Access Report

**New Residential Development**  
6-8 Grant Street  
Maitland NSW 2320

For: Brown Commercial Buildings  
Ref: PAA\_23527

prepared by:			
Lee-May Whong	Draft	Issued for review	14 March 2024
	Revision 1	Issued for DA	18 March 2024

Figure 2 | Overall Site Plan

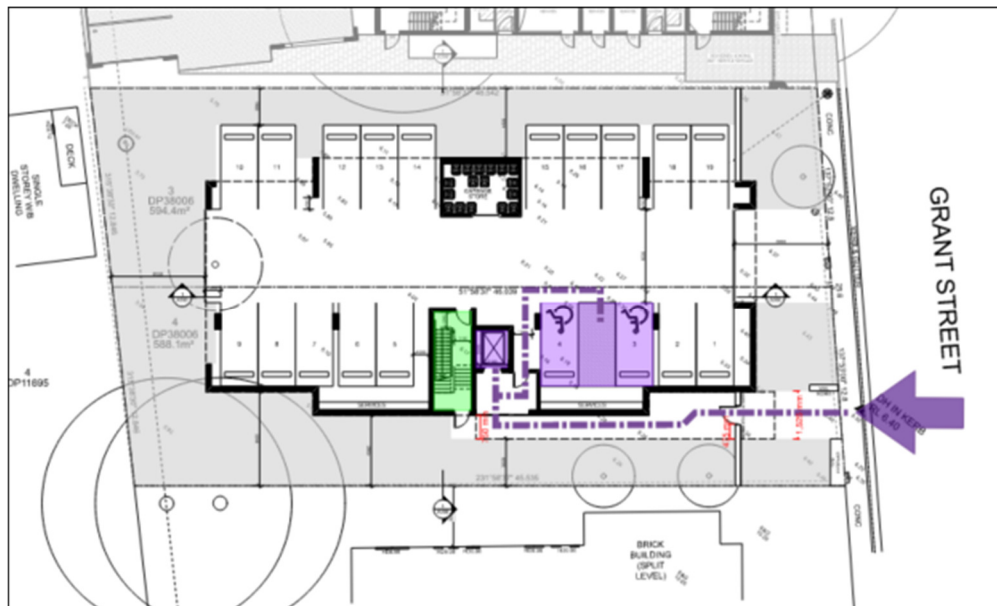
An accessible path of travel is provided to the building entrance from the allotment boundary along Grant Street via a formed footpath. Site levels indicate that on-grade access is achievable.

Footpaths that form the approach to the building are a dimensioned at a minimum 1500mm wide. Site levels indicate a level surface is achievable.
